# Rear Impact Guard Inspection

**Issue Overview:** This inspection covers specific model years of 2015 and 2016 for the Walker TTT with a 54" tandem setting. There is a potential for cracks to develop in the rear impact guards (Fig 1-3). Specific locations of the welded brackets require inspection until units can be repaired.

Figure 4

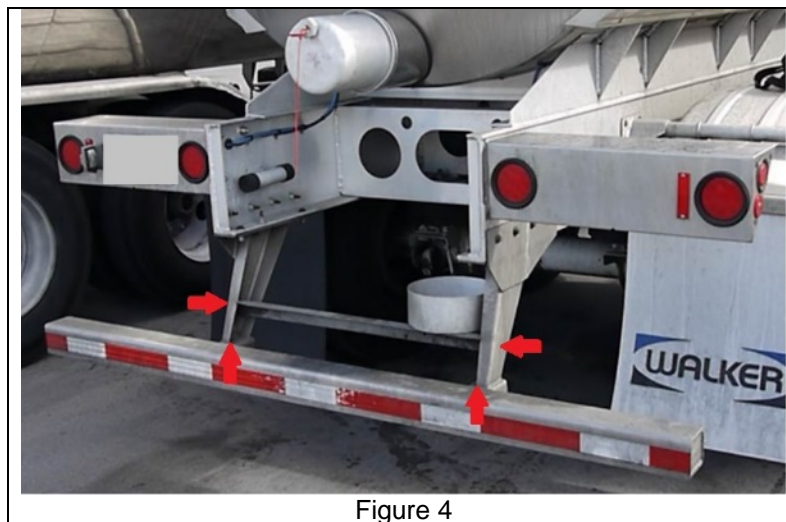
Arrows indicate areas of inspection

**Inspection:** Inspect the welded bracket(s) for cracks (Fig 4). Rear impact guards with cracks need addressed ASAP.

**Next Steps:** A bumper modification bulletin is available and the Warranty group is working on a list of service providers who can perform it. For any questions, please contact the Warranty group at 608-562-7813.
